Emission Adjustments for Temperature, Humidity, Air Conditioning, and Inspection and Maintenance for On-road Vehicles in MOVES2014

Assessment and Standards Division
Office of Transportation and Air Quality
U.S. Environmental Protection Agency

Appendix D Response to Peer Review Comments on Chapter 2: Temperature Adjustments

Figure 2-1 FTP CO Start Emissions with Log-Linear Model Fit

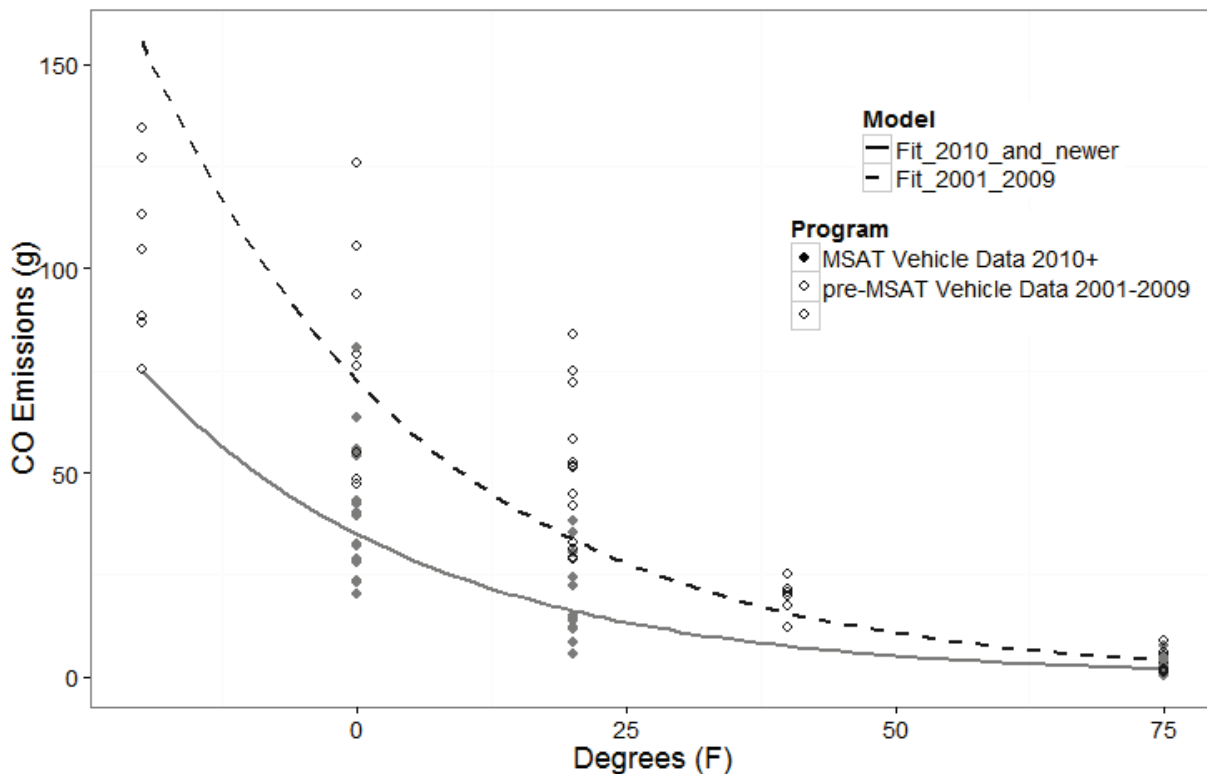
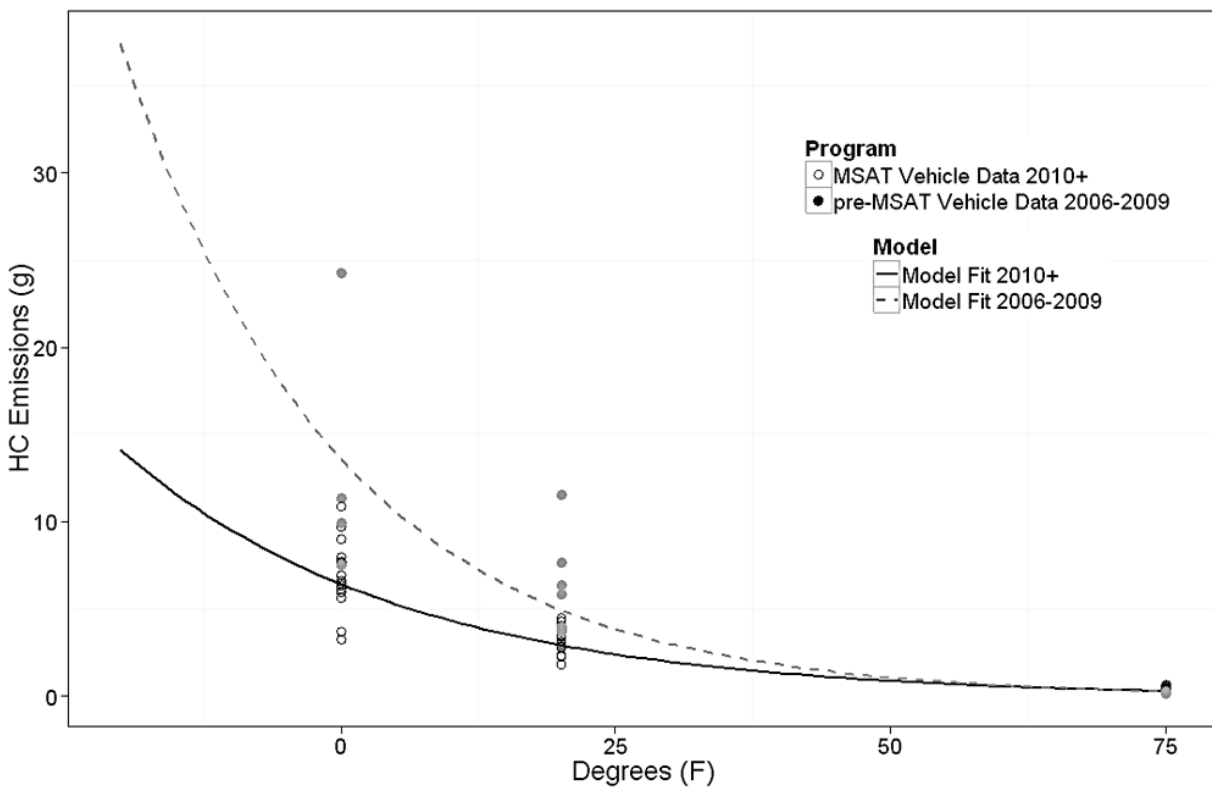
In Section 2.2.1, it is important to show, either here or in an appendix, the original data and the fitted regression models, along with disclosure of the coefficient of determination of each model, and the t-ratio and p-value of each coefficient. Just showing model predictions is not enough – information should be given so that it is clear how the model parameters were estimated and regarding the goodness-of-fit of these models. It is also important to be clear as to what results are statistically significant.

RESPONSE: We added tables with the model parameter estimates, and the t-ratio and p-values of the estimated model parameters in Table 2-3, Table 2-4, Table 2-5. We also added discussion about our model fitting procedures, and the rationale behind selecting the final model.

The terms “significant difference” and “statistical difference” are used to indicate a p-value of < 0.05 . Also, the data can be viewed graphically in Figure 2-1 and Figure 2-2.

Figure 2-7. FTP PM_{2.5} Start Emissions, MSAT-2 Compliant Vehicles (7 PFI vehicles, 40 tests with nonzero PM measurements on E10 fuel)

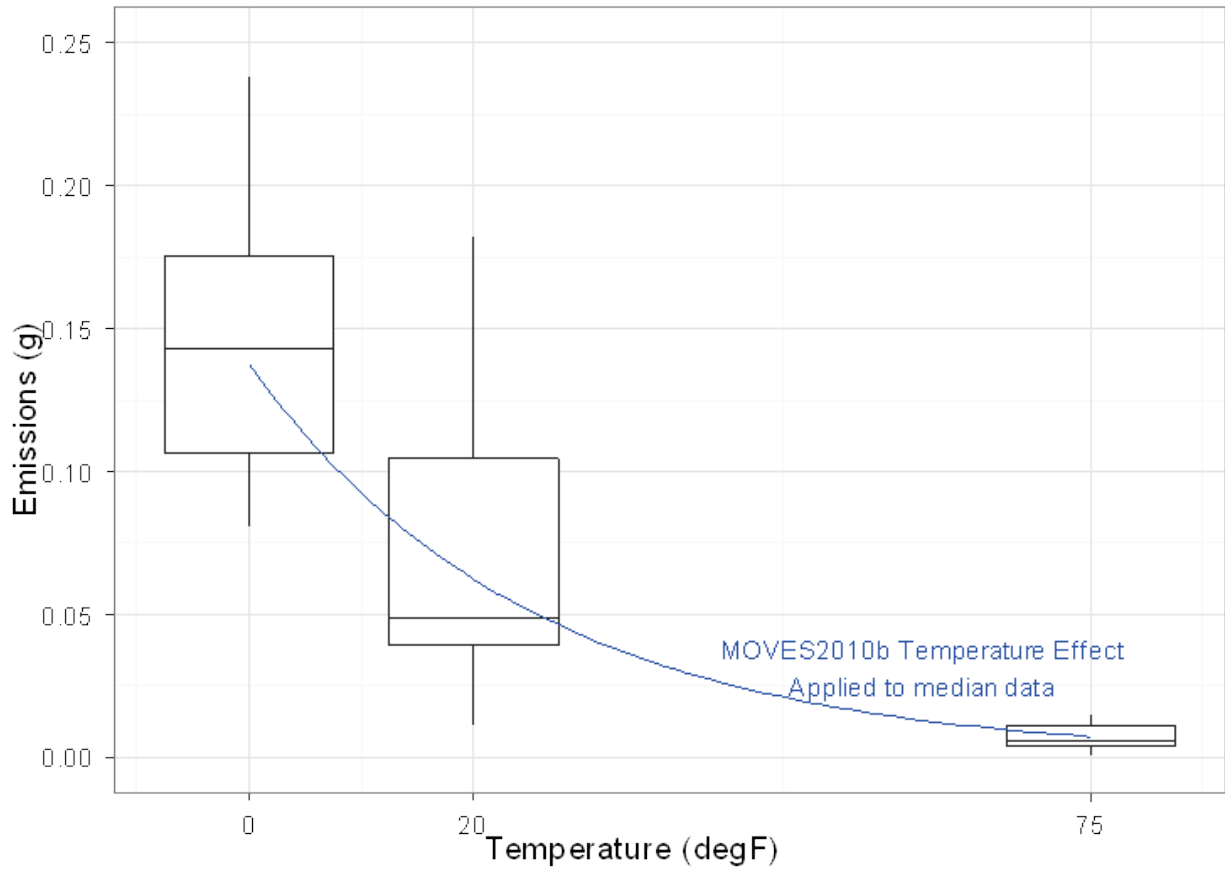
Figure 2-6 [now Figure 2-7]: is this for total PM, PM10, PM2.5? It is useful to show mean values also. Also indicate sample size.

RESPONSE: We added PM2.5, and the sample size to the heading of Figure 2-7. For purposes of the qualitative comparison, we believe that showing the distribution of the data, without the mean, is sufficient to show that the data compare well.

Figure 2-10. Hot-Running PM Emissions Measured on Two Cycles (FTP Bag 2, US06) on MSAT-2 compliant MY 2010 gasoline vehicles, reported as grams/cycle.

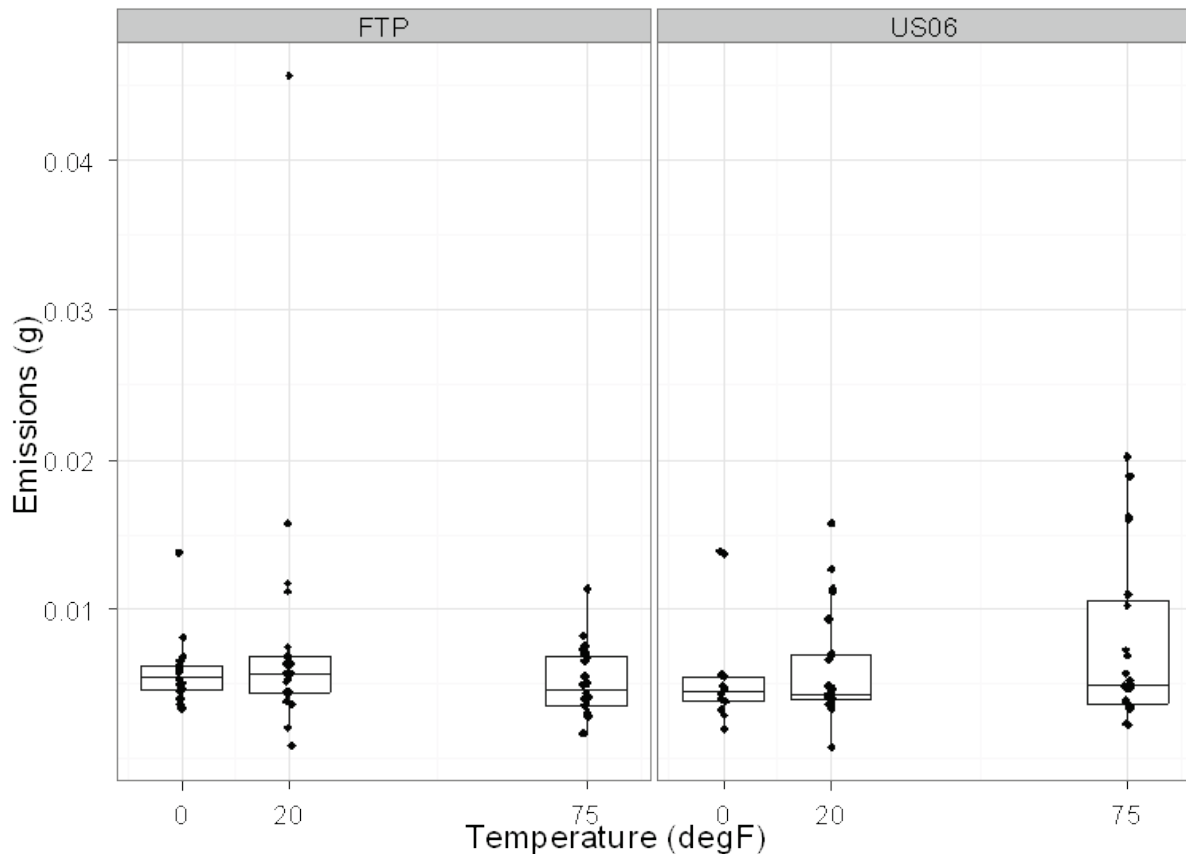
Page 21 – middle of page says “no significant temperature effect is observed in either cycle.” Figure 2-8 gives some hint that there may be an effect for the US06 cycle. However, if there is an effect, it may be on the mean rather than the median “emissions”. Is this total emissions or some kind of emissions increment... not very clear. If this is a hot running emissions, why is it not in units of mass per mile? In general, it is helpful to indicate sample sizes of data sets and to also indicate the mean value in box and whiskers plots.

RESPONSE: We added text explaining that we fit log-linear models to the data, and found no statistically significant temperature effect. The units .

Figure 2-13 Mean Light-Duty Diesel Cold-Start HC Emissions (in grams) with 90% Confidence Intervals vs Temperature.

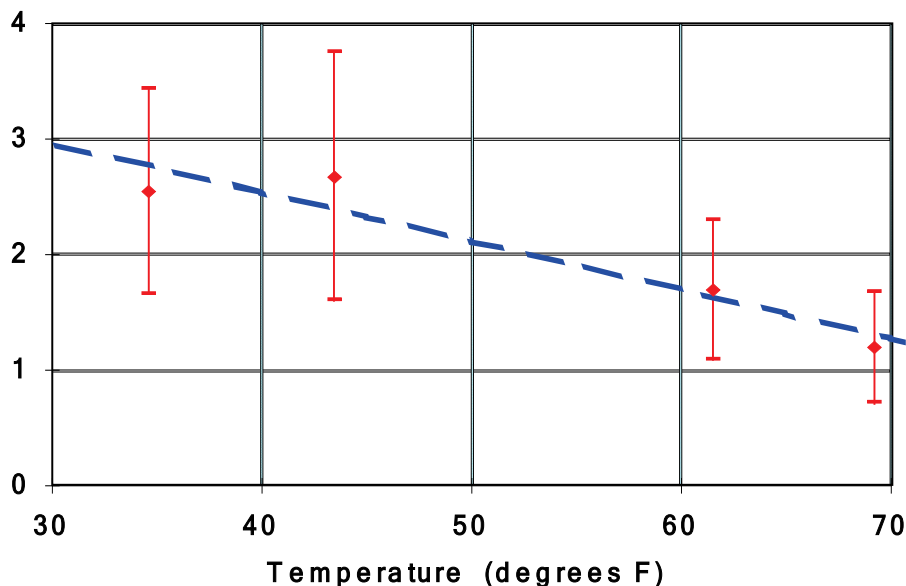
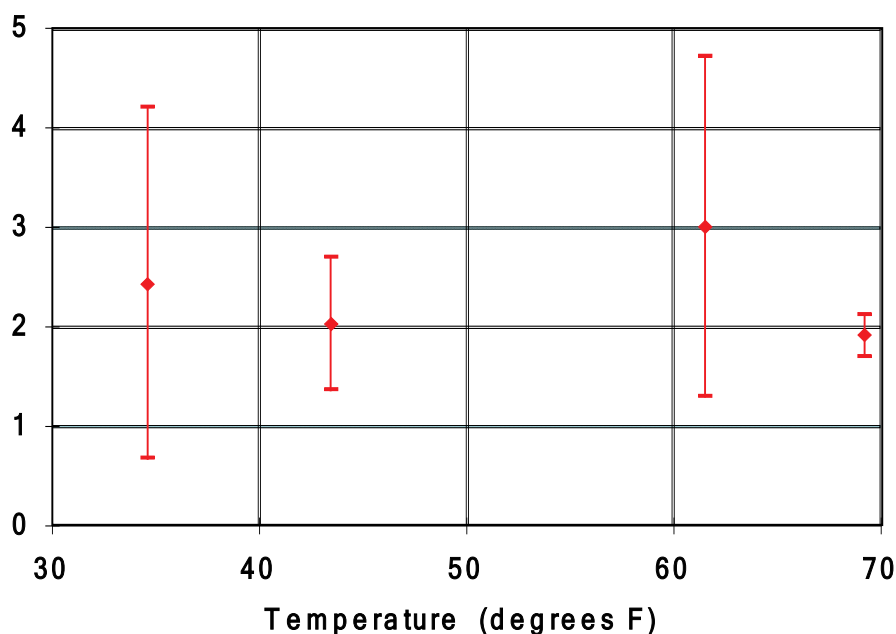
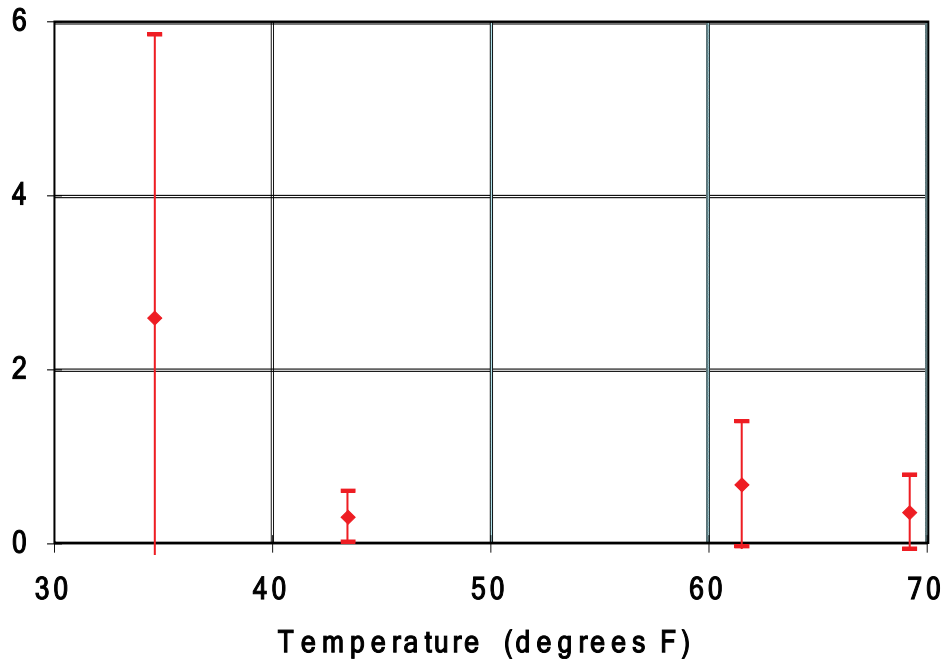
Table 2-8... please be clear as to what type of diesel vehicle is represented here (see above). Also, explain the basis of the confidence intervals shown in Figure 2-10 – are these actually CI on the mean, or are they a range of variability in the data?

RESPONSE: We added text to Table 2-9 heading stating that the data are from light-duty diesel vehicles. We also added text on Figures 2-10, 2-11, and 2-12 stating that the graph plots the means, to reflect the definition of the confidence interval on the mean as stated in the text.
